# BUNDLED WIND POWER PROJECT IN KOPPAL KARNATAKA

| <b>Report ID</b>     | VKU.VER.113.23_VCS_1993                        |

| <b>Report Title</b> | Bundled Wind Power Project in Koppal Karnataka |

Figure No.- 01 below from google earth pro software shows the entire location of WTGs installed at Skeiron site.

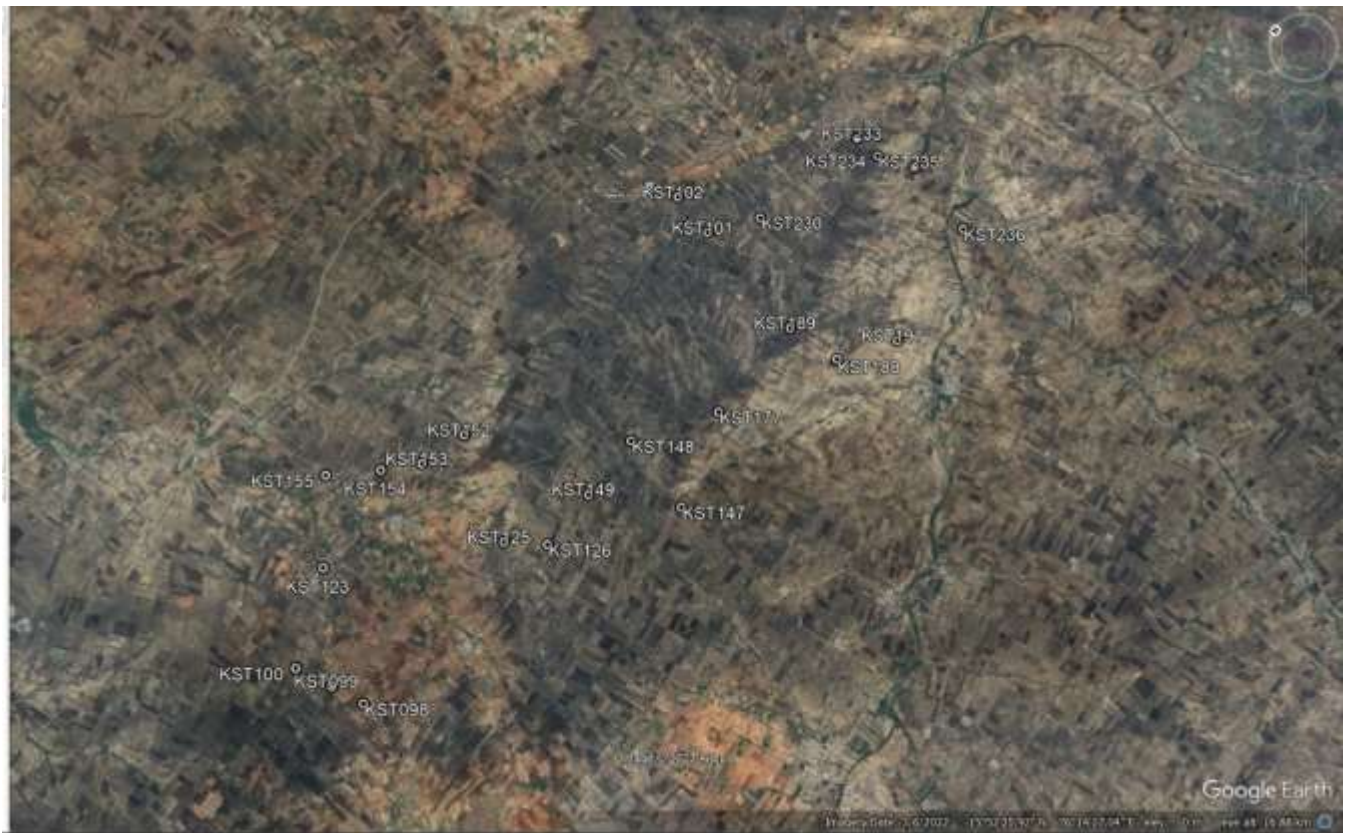
The location of all WTGs installed at the site is provided in Section 1.7 of MR/1/ which is verified by assessment team during desk review with the help of Google earth pro/20/ and some inconsistencies were observed which were updated by PP and it is confirmed through Google earth pro software/20/ and found to be correct, and it is further cross verified during site visit with the help of GPS map camera/19/. hence accepted by VKU assessment team.
